Access Compliance Report

Public Rights-of-Way

(Curb Ramps)

Intersection ID: 14652	Main Street: DRIFTWOOD_DR	Cross Street: MCMANUS_DR	Location: SE
ADA ID: 6A4DBCA61F76	Ramp Type: Directional1	Initial Pass/Fail: Pass	Overall Compliance: No
Severity Score: 6.5			
Codes/Mitigation Info/Possible Solution		Field Measurements/Component Compliance

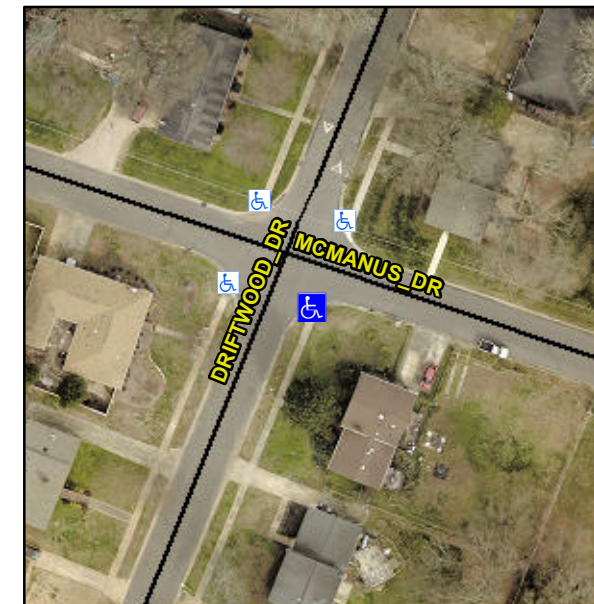
**Not Found, R304.2.1, R304.5.3,
R305.1.4, R305.2**

Compliance	Description	Data	Compliance	Description	Data
N/A	Ramp Length (in)	80.0	Yes	Grade Break?	Yes
Yes	Ramp Width (in)	48.5	Yes	Grade Break Slope (%)	0.6
Yes	Ramp Slope (%)	1.2	No	Grade Break XSlope (%)	3.4
Yes	Ramp XSlope (%)	0.8			
N/A	Flare Type LT	N/A	N/A	Flare Type RT	N/A
N/A	Flare Slope LT (%)	5.1	N/A	Flare Slope RT (%)	1.3
N/A	Flare Traversable LT?	No	N/A	Flare Traversable RT?	No
No	Landing Length (in)	47.5	Yes	DWS Provided?	Yes
No	Landing Width (in)	47.5	Yes	DWS Contrast?	Yes
Yes	Landing Slope (%)	0.0	Yes	DWS Length (in)	24.0
No	Landing X Slope (%)	2.2	No	DWS Full Width?	No
N/A	Landing Curb? (Y/N)	No	Yes	DWS Offset LT (in)	45.0
N/A	Shared Landing?	No	No	DWS Offset RT (in)	3.5
Yes	Gutter Ponding?	No	Yes	Gutter Slope (%)	0.3
Yes	Gutter Lip Ht (in)	0.0	No	Gutter X Slope (%)	3.0
N/A	Painted X Walk1?	No		Road Slope (%)	8.5
	X Walk 1 Direction	To NE		Road X Slope (%)	0.2
	X Walk 1 Width (in)	N/A		Clear Space?	Yes

X Walk 1 Slope (%)	8.5	N/A	Clear Space to XWalk (in)	N/A
	X Walk 1 X Slope (%)	0.2	Yes	Storm Grate/Utility Hazard?	No
N/A	Ramp inside XWalk1?	N/A		Storm Grate/Utility Type	
Yes	Any Obstructions?	No			N/A
	Obstruction Type		Yes	Surface Condition? (G/P)	Good
			N/A	Curb Slope (%)	16.8

**Remove & Replace Entire Ramp.
Remove & Replace Gutter.**
